CITY OF GOODLETTSVILLE PLANNING COMMISSION

CITY OF GOODLETTSVILLE PLANNING COMMISSION

STAFF AGENDA REPORT

Monday May 6, 2024 5:00 PM

Sheet Number L1.00

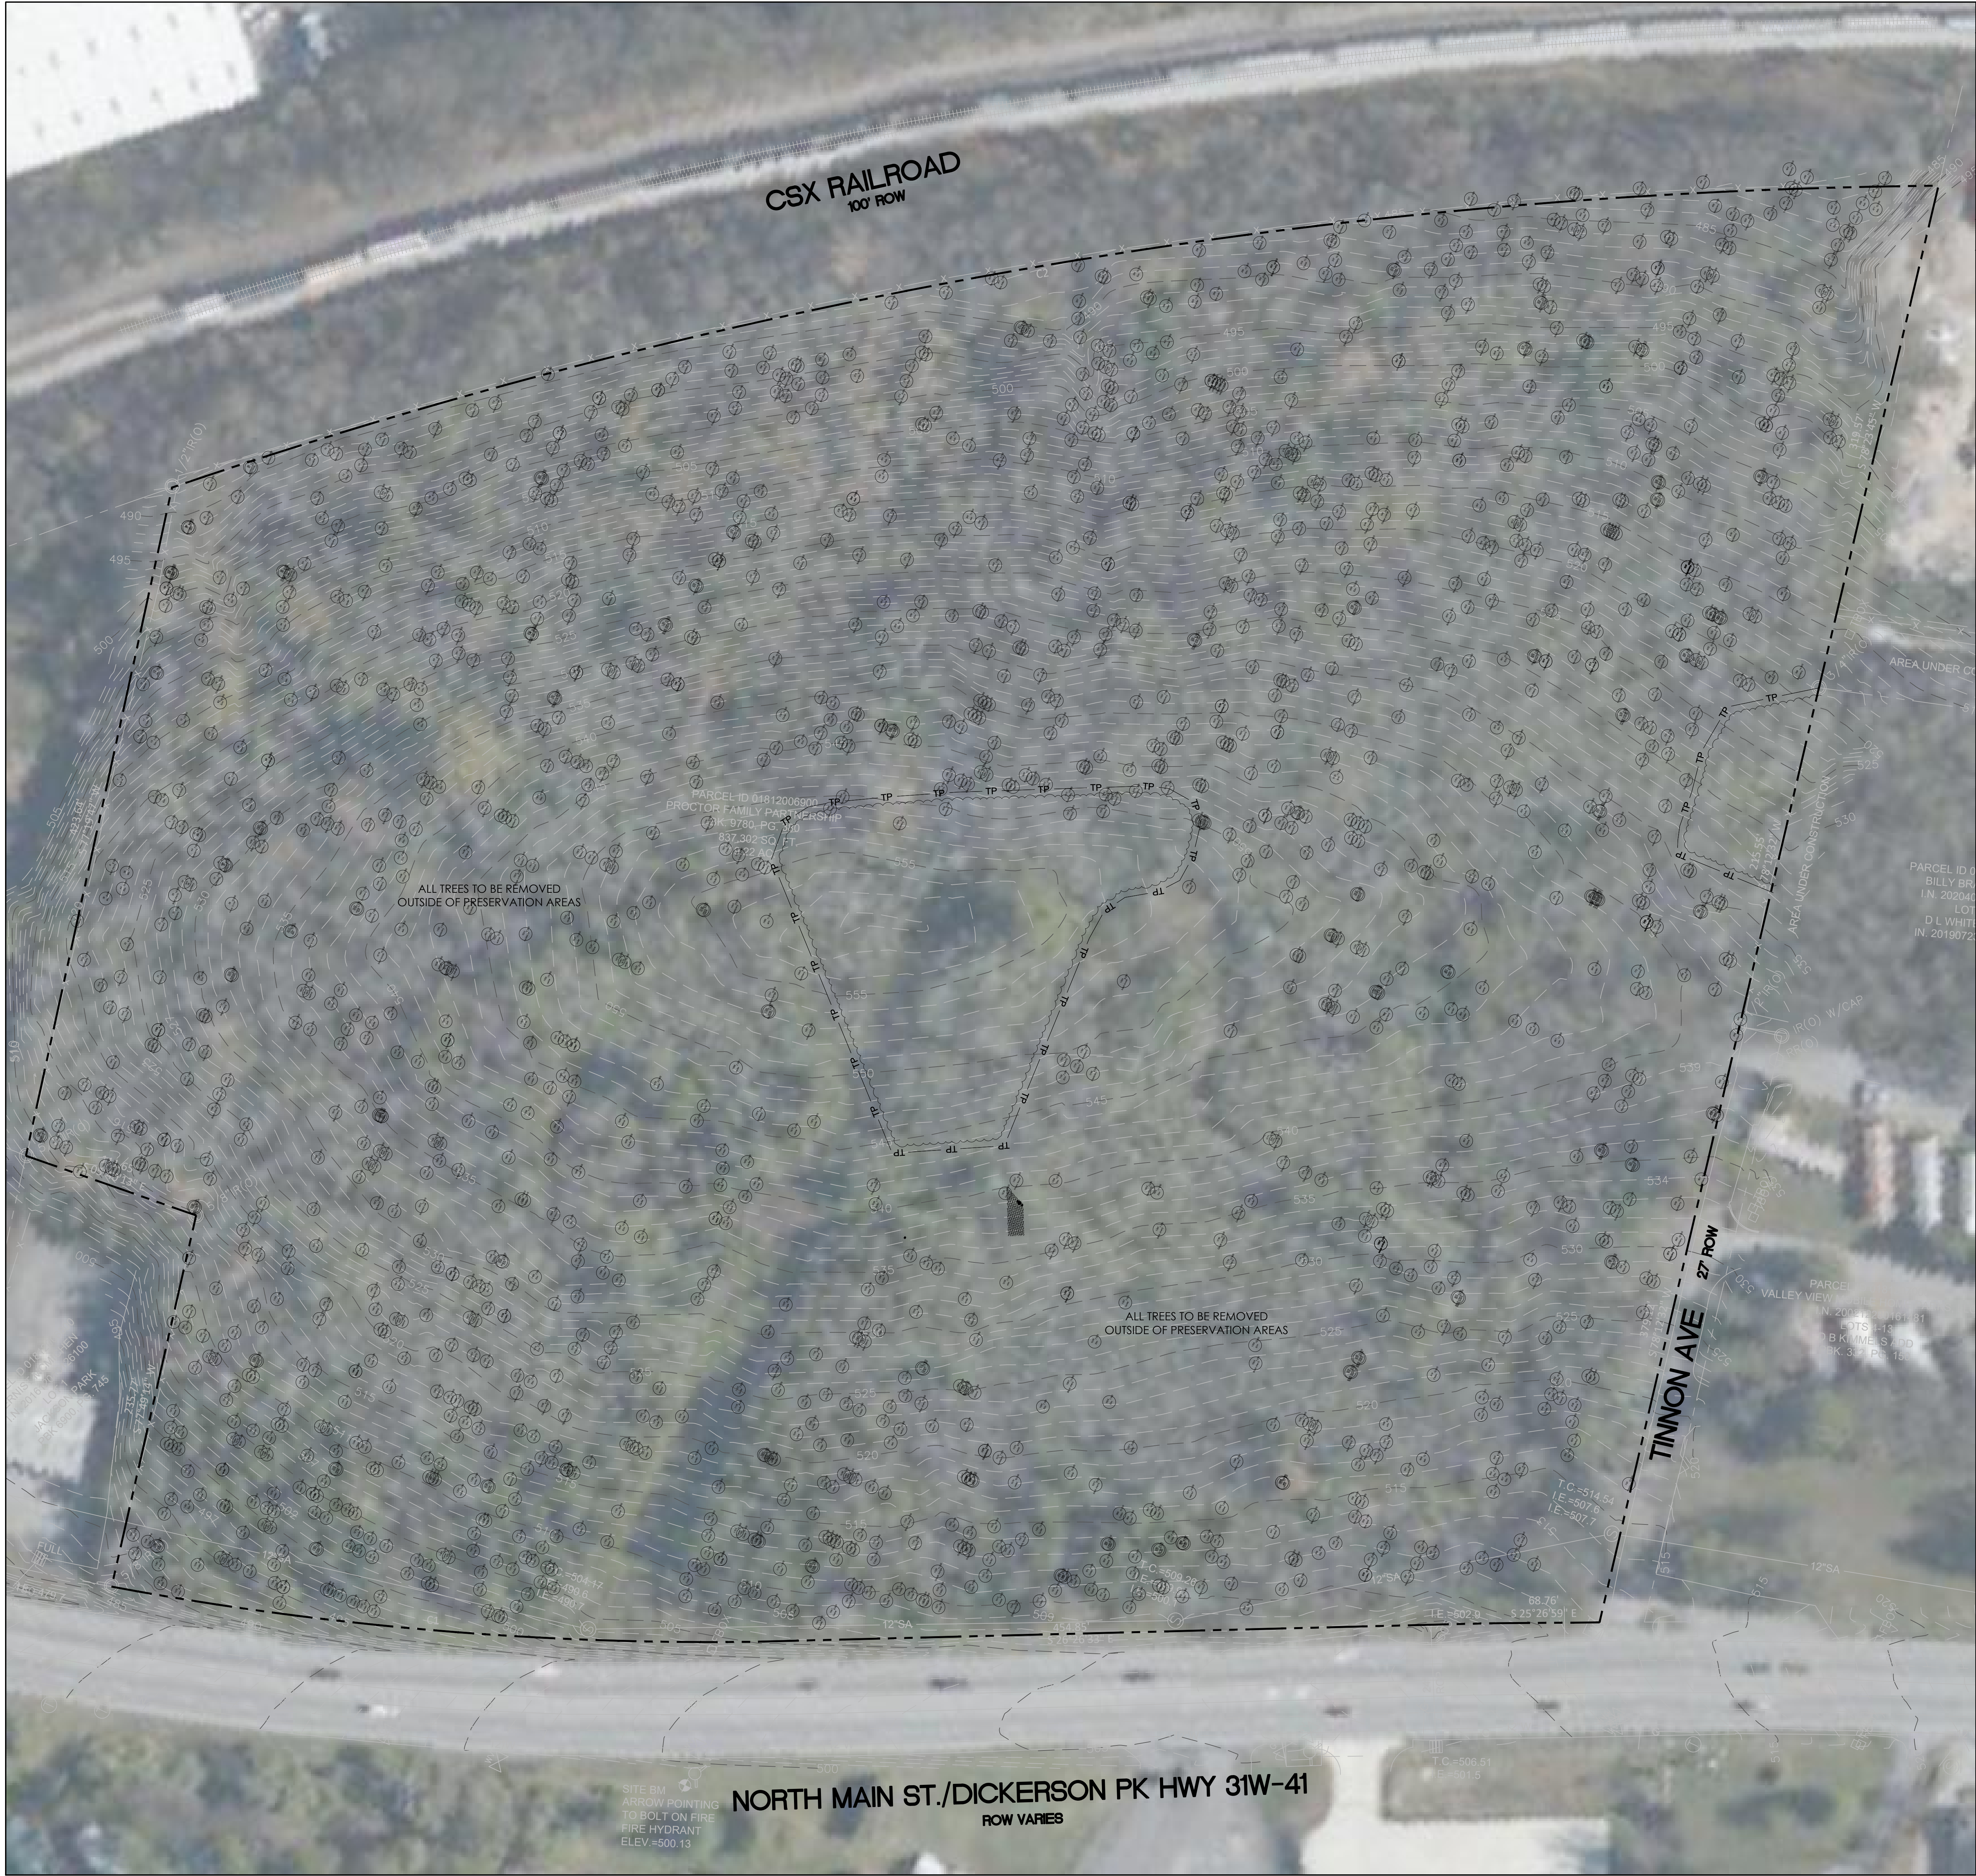
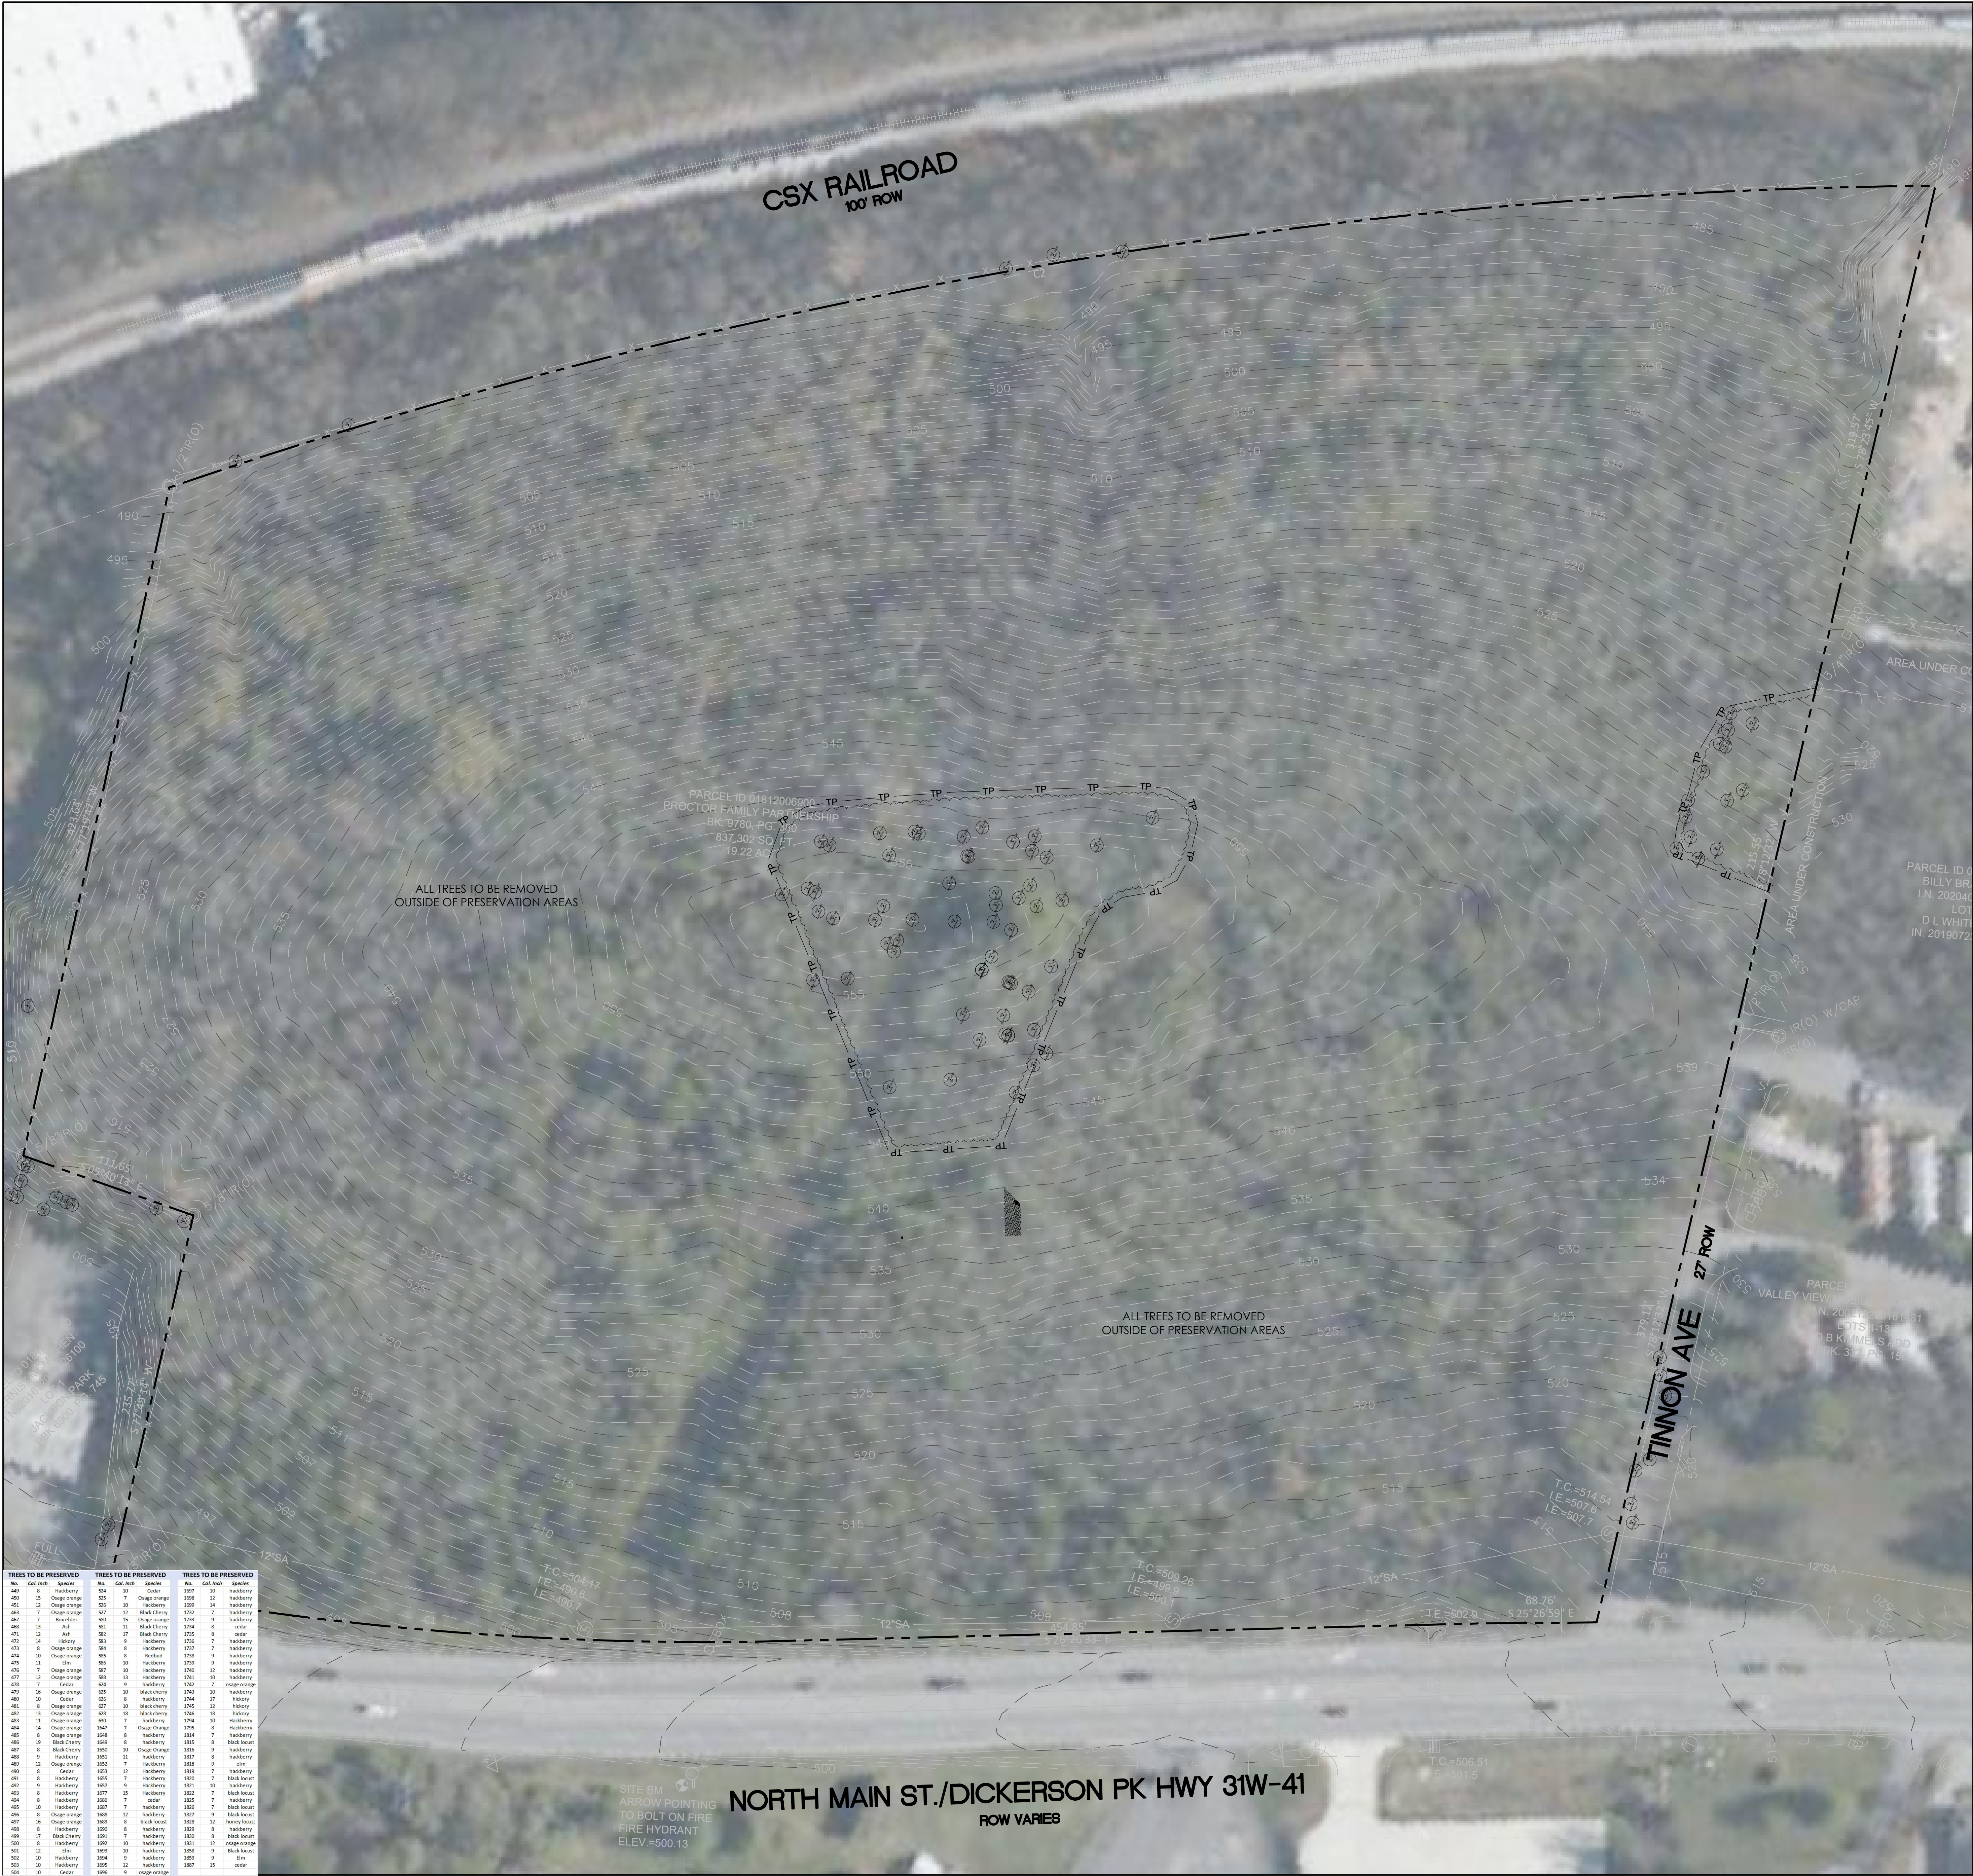
The proposal is to change the site grading and landscaping design at the back of the site adjacent to CSX railroad tracks. The Planning Commission previously approved a revised site grading and landscaping design with a retaining wall along the rear property boundary. Multiple sections of the stacked retaining wall failed after installation due to soil issues. The revised proposal is to maintain a section of the retaining wall and regrade the remaining area. A smaller height retaining wall is proposed up the slope with the revised design to maintain a 3:1 designed slope for stability and landscaping. The revised retaining wall section is adjacent to the project utility access drive. The revised landscaping plan has been provided including revised planting to

maximize the slope stability design. The City's engineer consultant reviewed the revised plan and requested a correction on the plan to ensure the 3:1 slope and the owner provide a geotech study to confirm the slope stability design plan.

1. Revised plan to meet City's engineer consultant comments about correct designed slope and geotech study confirmation.
